# Access Compliance Report

## Public Rights-of-Way

### (Curb Ramps)

Intersection ID: 3528	Main Street: MALLARD_CREEK_RD	Cross Street: SAWGRASS_RIDGE_PL	Location: NW
ADA ID: 48D3E849A99B	Ramp Type: Perp	Initial Pass/Fail: Fail	Overall Compliance: No
Severity Score: 25			
Codes/Mitigation Info/Possible Solution		Field Measurements/Component Compliance

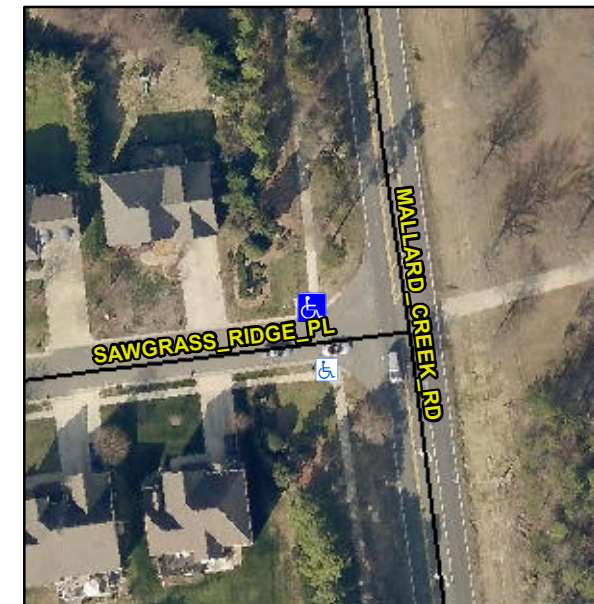
**R304.2.2**

Compliance	Description	Data	Compliance	Description	Data
N/A	Ramp Length (in)	50.0	No	Ramp Slope (%)	12.5
Yes	Ramp Width (in)	48.0	Yes	Ramp XSlope (%)	0.7
N/A	Flare Type LT	N/A	N/A	Flare Type RT	N/A
N/A	Flare Slope LT (%)	N/A	N/A	Flare Slope RT (%)	N/A
N/A	Flare Traversable LT?	N/A	N/A	Flare Traversable RT?	N/A
N/A	Landing Length (in)	N/A	N/A	DWS Provided?	N/A
N/A	Landing Width (in)	N/A	N/A	DWS Contrast?	N/A
N/A	Landing Slope (%)	N/A	N/A	DWS Length (in)	N/A
N/A	Landing X Slope (%)	N/A	N/A	DWS Full Width?	N/A
N/A	Landing Curb? (Y/N)	N/A	N/A	DWS Offset (in)	N/A
N/A	Shared Landing?	N/A			
N/A	Gutter Ponding?	N/A	N/A	Gutter Slope (%)	N/A
N/A	Gutter Lip Ht (in)	N/A	N/A	Gutter X Slope (%)	N/A
N/A	Painted X Walk1?	No	N/A	Painted X Walk2?	N/A
	X Walk 1 Direction	To S		X Walk 2 Direction	N/A
N/A	X Walk 1 Width (in)	N/A	N/A	X Walk 2 Width (in)	N/A
	X Walk 1 Slope (%)	6.0		X Walk 2 Slope (%)	N/A
	X Walk 1 X Slope (%)	1.7		X Walk 2 X Slope (%)	N/A

**Remove & Replace Entire Ramp.**
